SUNDRY NOTICES AND REPORTS ON WELLS
Do not use this form for proposals to drill or to re-enter an
abandoned well. Use Form 3160-3 (APD) for such proposals.

8. Well Name and No
Carbon Valley 25 Fed Com #8H

9. API Well No
30-015-39851

**Carbon Valley 25 Fed Com 8H
30-015-39851
Murchison Oil and Gas, Inc.
September 22, 2012
Conditions of Approval**

Exhibit G-2 Carbon Valley 25 Fed 8H Choke Manifold

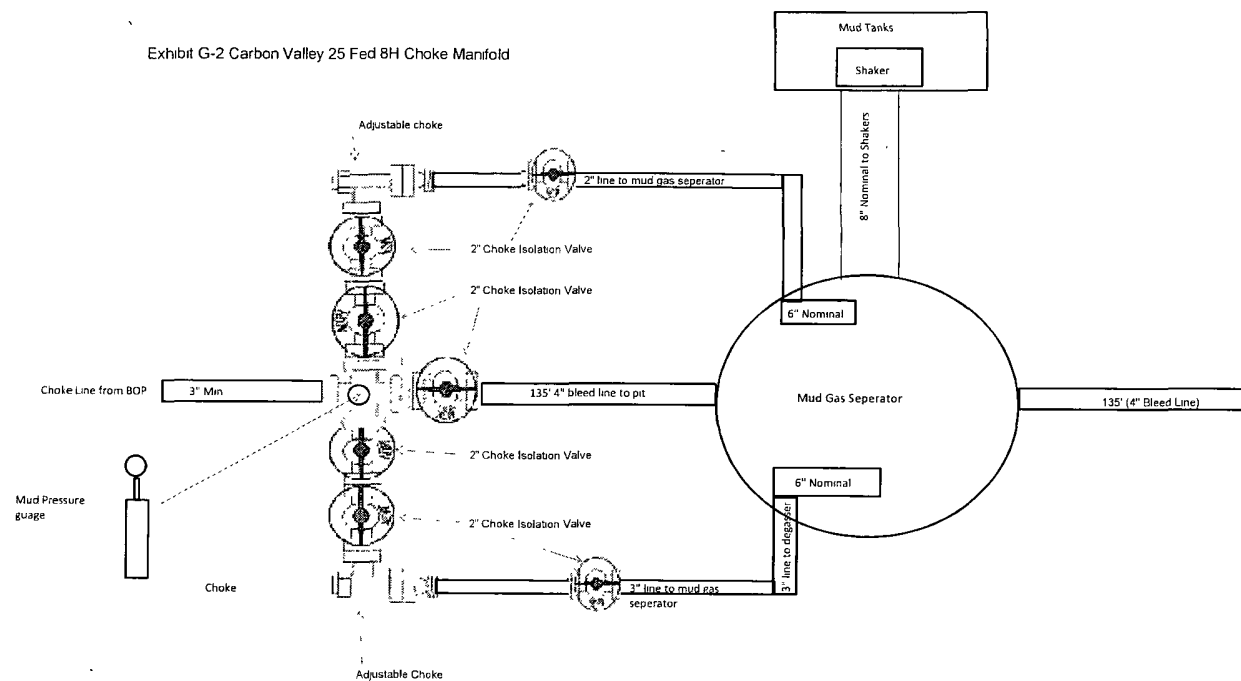
We respectfully request that the choke line from the BOP stack to the Choke Manifold to be used will change from a flanged line to a flanged 5000psi hose. The hose has been pressure tested to 5000psi. Attached is the hose certification from the manufacturer. As well we request that we change the rig from McVay #4 to HWD #4 (see attached rig layout), and change the BOP and Choke manifold (see attached schematics)

3. BOP and choke manifold approved as presented.. Operator approved to test to 3000 psi.
